Palo Verde Nuclear  
Generating Station

**Subject: Palo Verde Nuclear Generating Station (PVNGS)  
Unit 2  
Docket No. STN 50-529  
Request for a License Amendment to Support Replacement of Steam  
Generators and Up-rated Power Operations**

**ATTACHMENT 2**  
**LICENSE AMENDMENT REQUEST ANALYSIS**

**MARKED-UP OPERATING LICENSE AND  
TECHNICAL SPECIFICATION PAGES**

Figure 3.4.1-1  
Reactor Coolant Cold Leg Temperature vs. Core Power Level

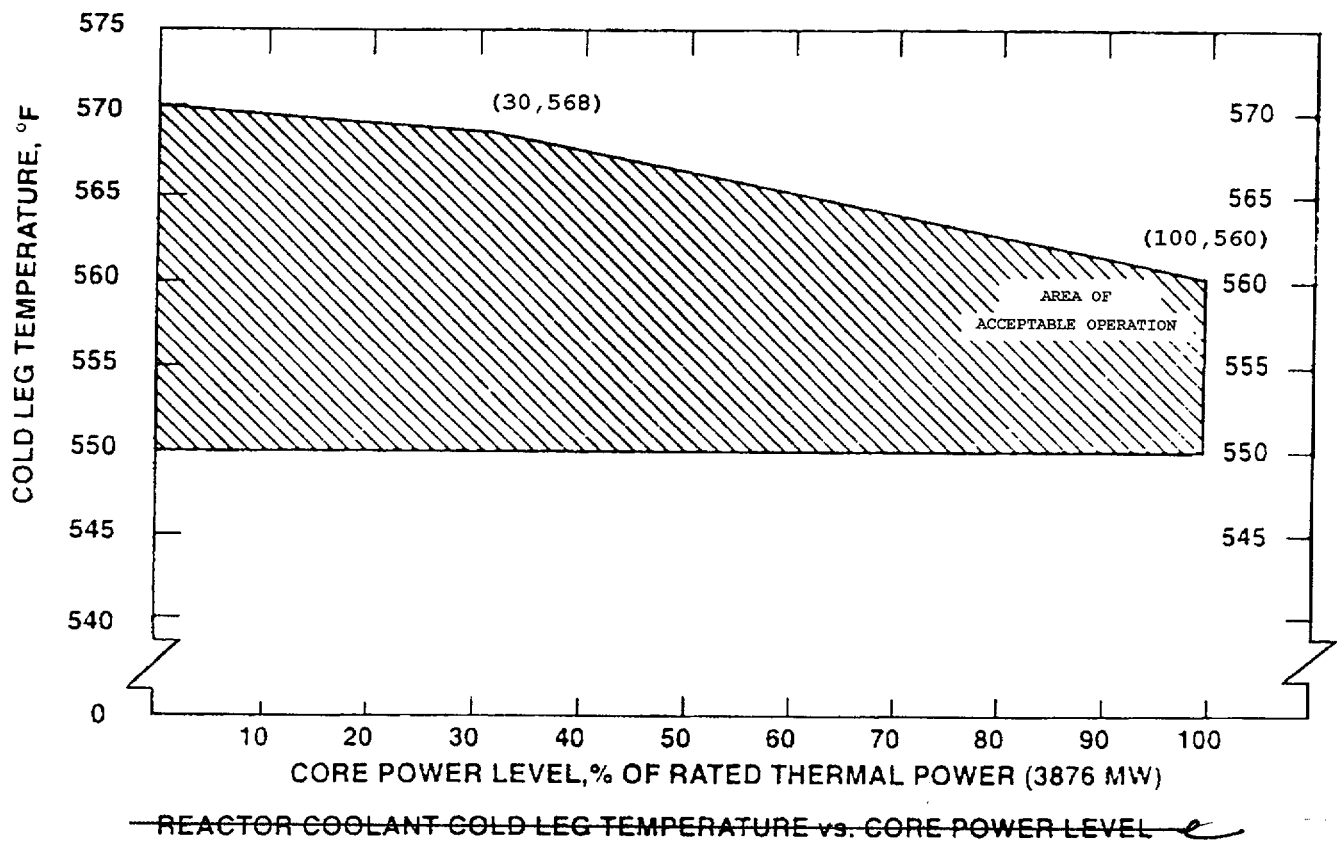
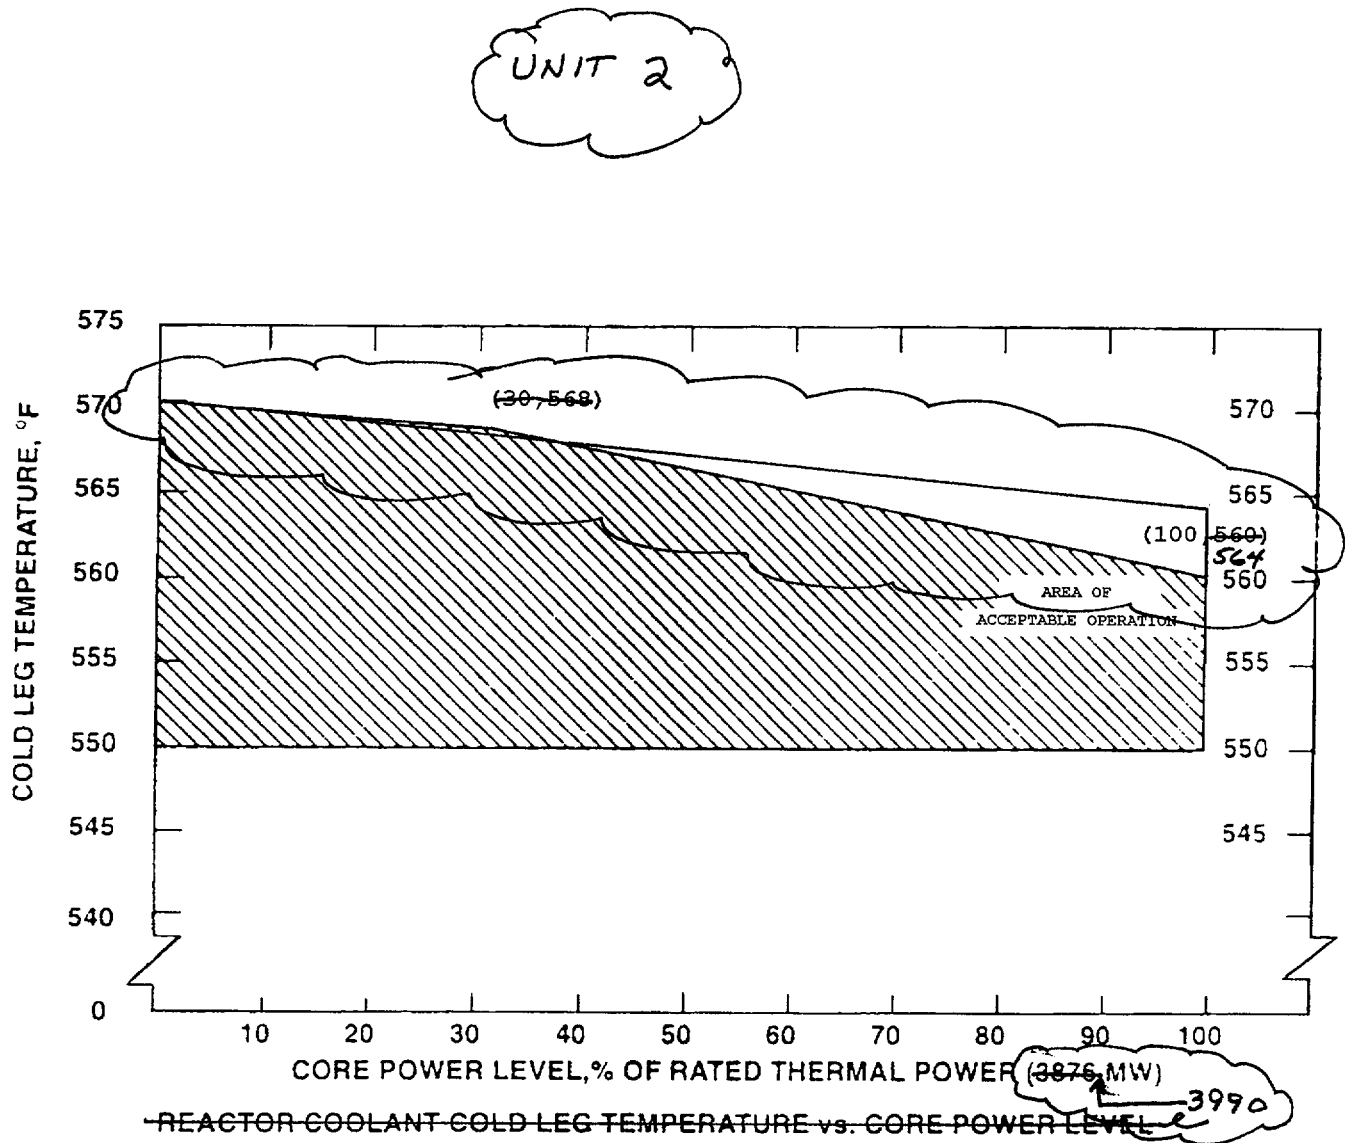
- F. Revise Figure 3.4.1-1, Reactor Coolant Cold Leg Temperature vs. Core Power Level, to change the upper limit in the area of acceptable operation for Unit 2. The new

upper limit line would allow a cold leg temperature of 570 °F at 0% power, decreasing linearly to 564 °F at 100% power. The upper limit line of Figure 3.4.1-1 in the current Technical Specification decreases linearly from 570 °F at 0% power to 568 °F at 30% power. At 30% power the current figure then decreases linearly from 568 °F to 560 °F at 100% power. The increase in cold leg temperature at 100% power will allow a more optimum main steam pressure for turbine operation. Additionally, editorial changes will be made to Figure 3.4.1-1 for Units 1 and 3. Both the power uprate and RSGs affect this specification.

Figure 3.4.1-1, Reactor Coolant Cold Leg temperature vs. Core Power Level, referenced in LCO 3.4.1, RCS Pressure, Temperature, and Flow Departure from Nucleate Boiling (DNB) Limits, provides parametric limits to ensure that the actual value of the reactor coolant cold leg temperature is maintained within the range of values used in the safety analysis. The safety analysis supporting this requested amendment uses the proposed new allowable cold leg temperature range (550 °F to 570 °F), and this proposed change maintains the basis for the cold leg temperature limits.
